# BNSF NORTHWEST DIVISION MEADOWDALE BEACH PARK RAILROAD BRIDGE

## SCENIC SUBDIVISION LINE SEGMENT 50 BRIDGE 21.8A AND BRIDGE 21.8B STRUCTURAL PLANS

**AS BUILT**

**DATE: JUNE 21, 2023**

SEATTLE, WA TO WENATCHEE, WA  
BRIDGE NUMBER 21.80A  
OVER LUNDS GULCH CREEK  
EDMONDS, WA  
GENERAL PLAN & ELEVATION  
PLAN NO: 0050-0021.800-001 SHEET: 01 OF 10

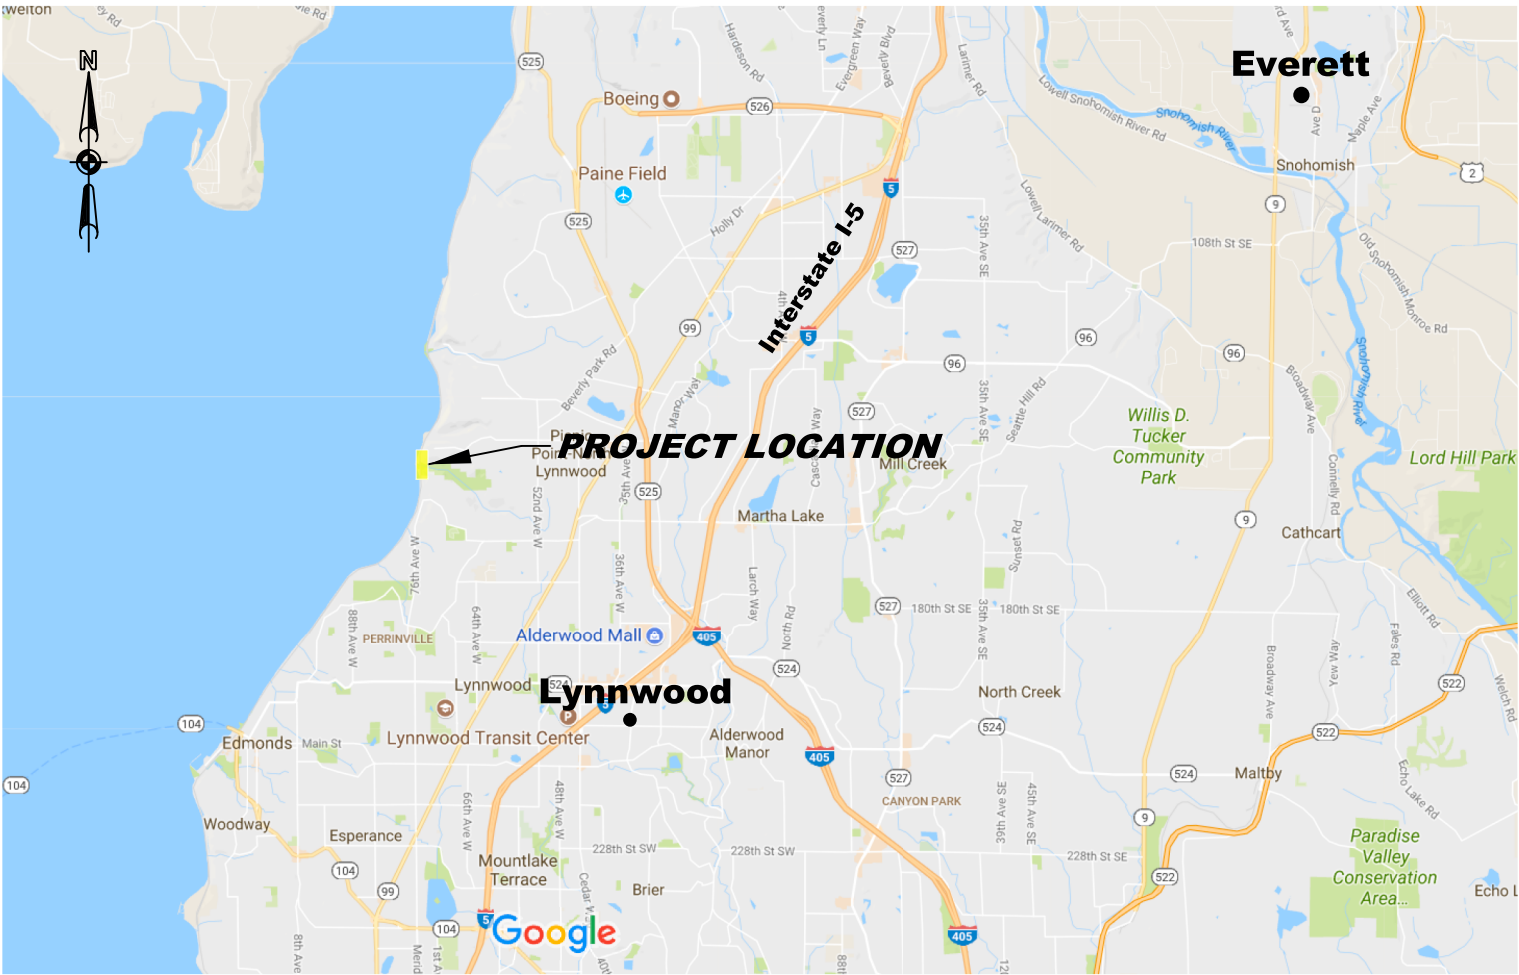
FOR FINAL PILE LENGTH BELOW CUTOFF, REFER TO SHANNON & WILSON REPORT "BNSF BRIDGE NUMBER 21.808 PILE DRIVING SUMMARY, MEADOWDALE BEACH PARK AND ESTUARY RESTORATION PROJECT, EDMONDS, WASHINGTON" DATED JULY 15, 2022.  
TOP OF RAIL ELEVATION PROVIDED FOR MAIN #2 IS THE LOWER INSIDE RAIL ALONG MAIN TRACK 2 - CLOSEST TO PARK SIDE. LAST SURVEY DATA PROVIDED BY DHA SURVEYORS ON OCTOBER 17, 2022.

1	4/22/2021	ADD BNSF SIGNATURE BLOCK	DES: TDP
2	6/12/2023	AS-BUILT PLAN NOTES	DRAWN: CDP
3	6/12/2023	SHEETPILE WALL REMOVED. RAISED CLEARANCE	CHECK: MAF
NO.		DATE	REVISIONS
		DATE	06/20/2023
		PLAN:	000335554
		LINE SEG:	0050

**TYPICAL SECTION - TEMPORARY SOIL RETENTION SYSTEM**  
BY COUNTY CONTRACTOR

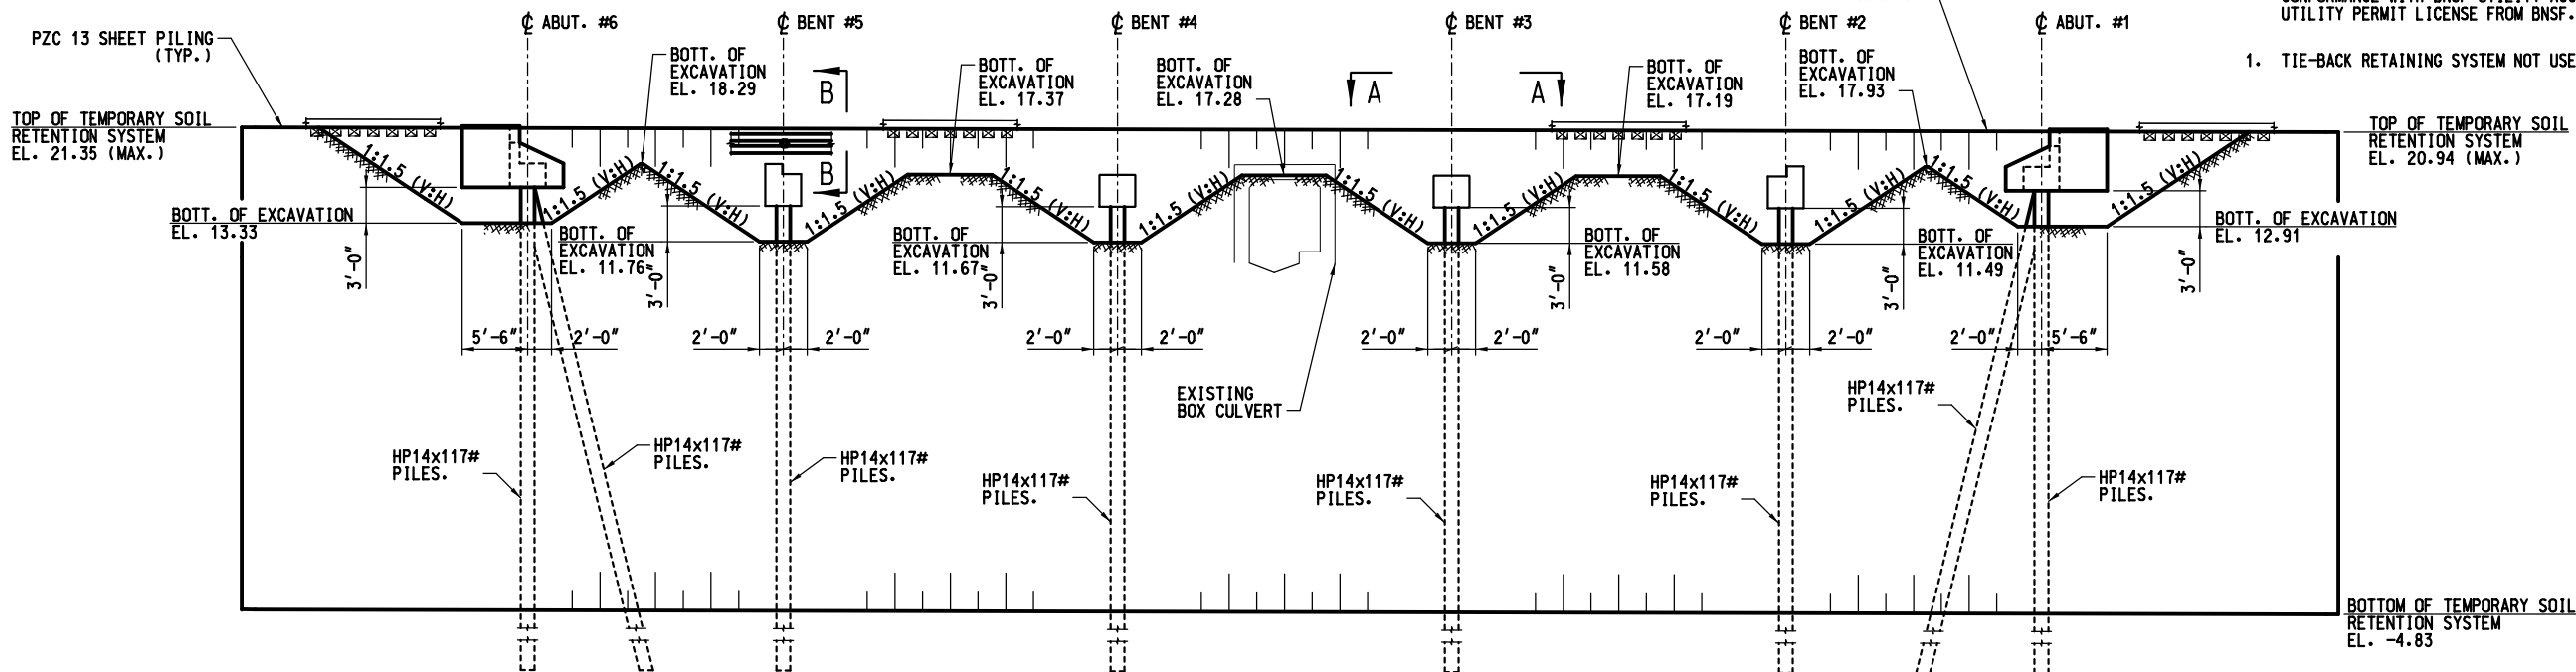
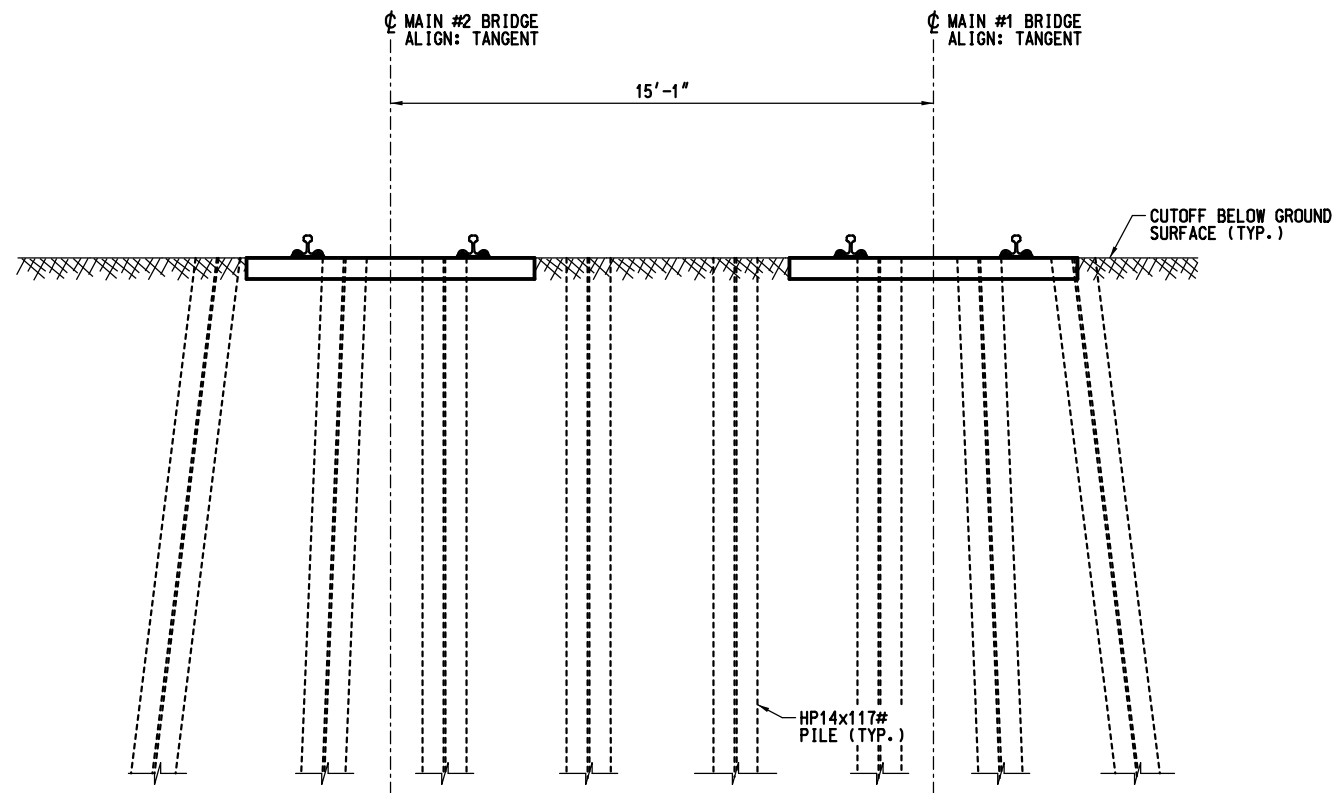
1. TIE-BACK RETAINING SYSTEM NOT USED.

SEATTLE, WA TO WENATCHEE, WA  
BRIDGE NUMBER 21.80A  
OVER LUND'S GULCH CREEK  
EDMONDS, WA  
CONSTRUCTION SEQUENCE  
STAGING SECTIONS I, II, & III  
PLAN NO: 0050-0021.800-004  
SHEET: 04 OF 10

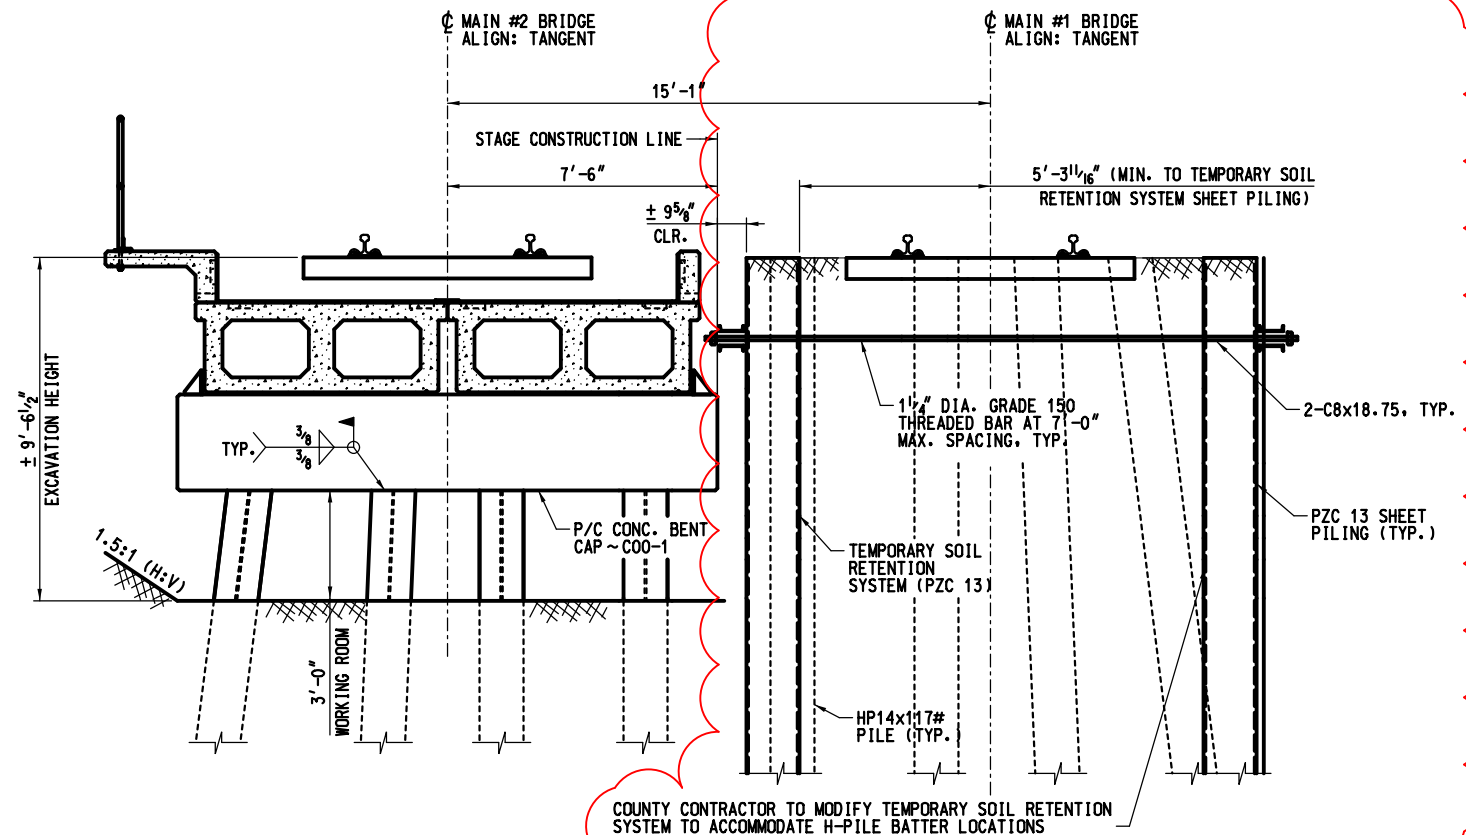
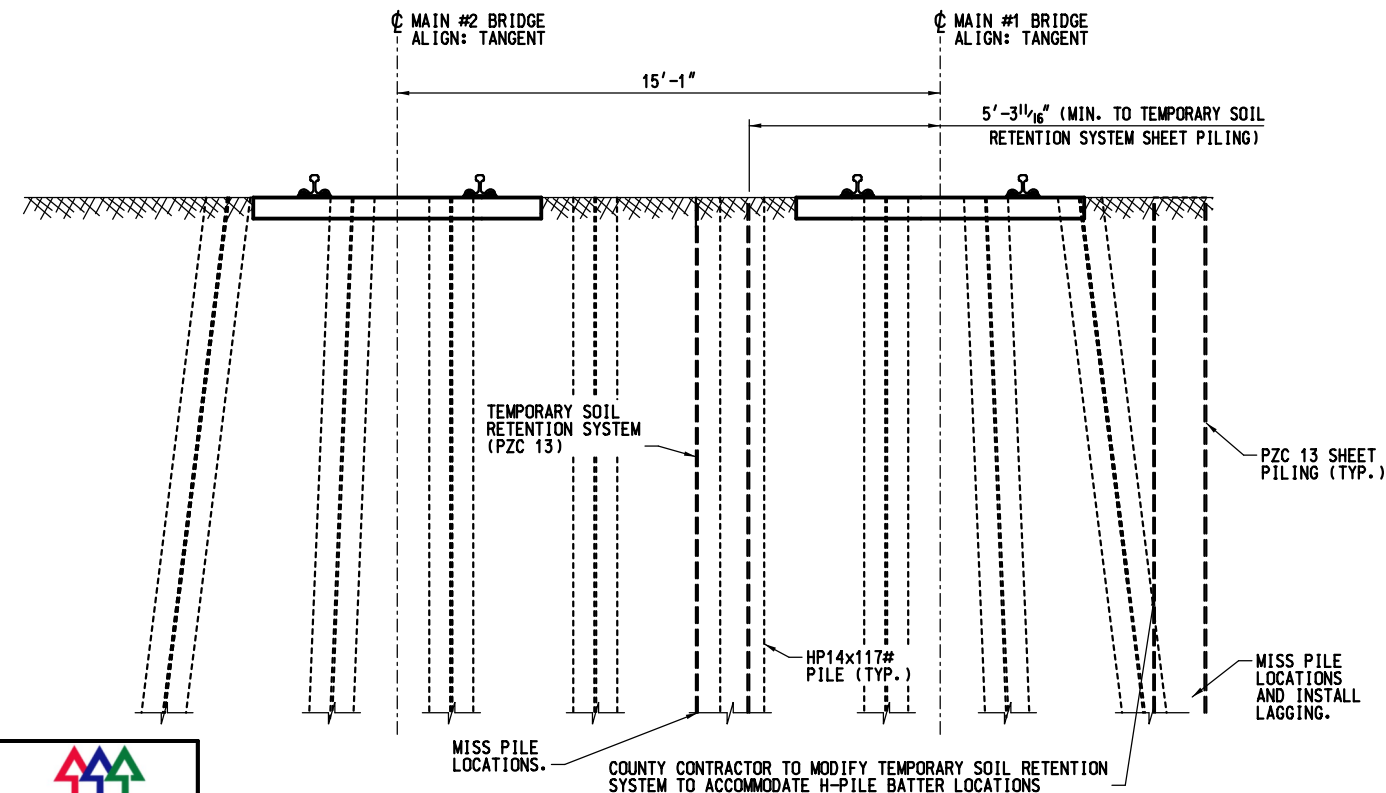
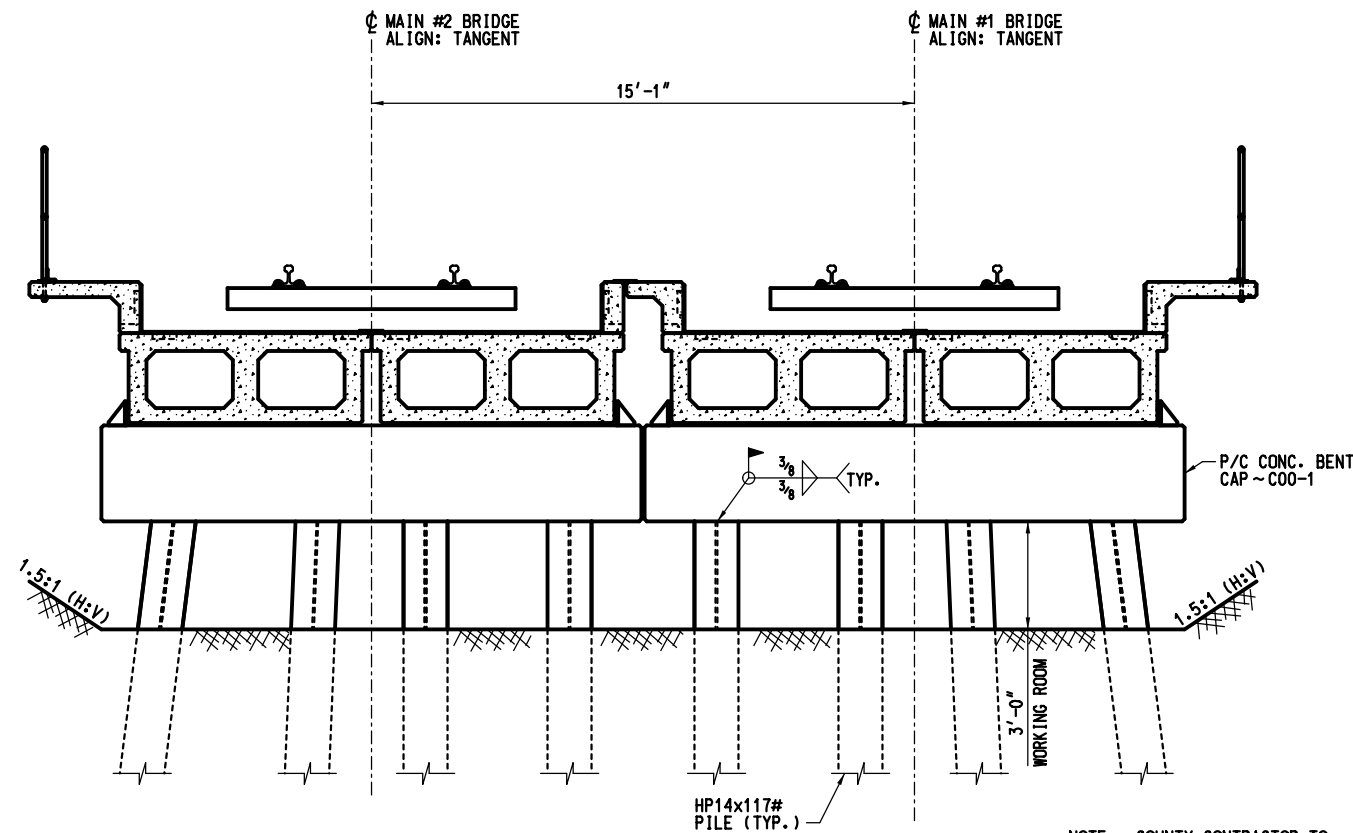
2 TEMPORARY SOIL RETENTION SYSTEM USED WAS SINGLE SHEET PILE WALL BETWEEN BOTH TRACKS. NO THREADED BARS USED. NO SHEET PILES WERE USED ON OUTER SIDES OF TRACKS.

**DECK DRAIN TYPICAL SECTION - BETWEEN BEAMS**

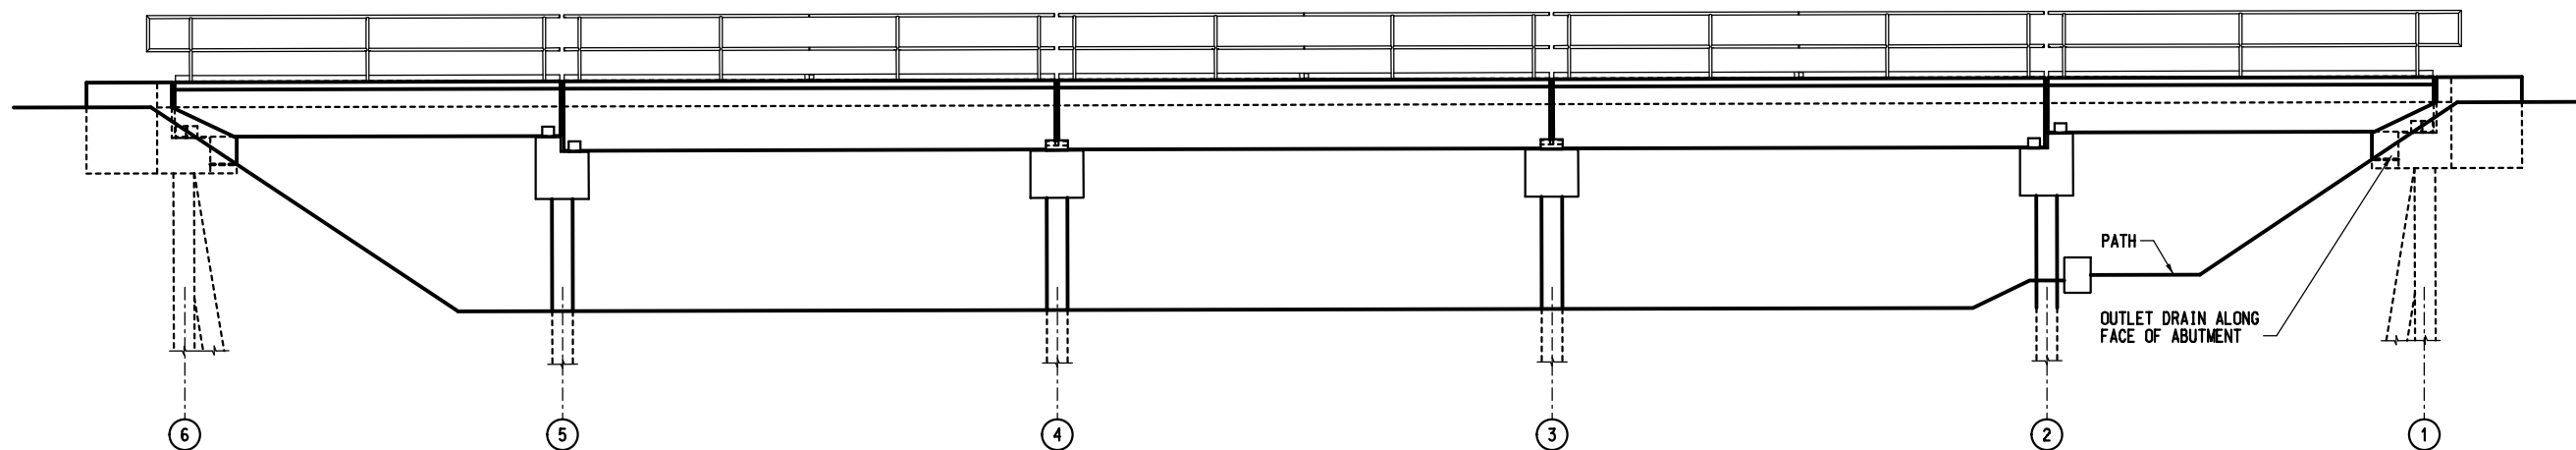
DRAINAGE SYSTEM REMOVED FROM SCOPE OF WORK.  
WATERPROOFING SYSTEM NOT INSTALLED.
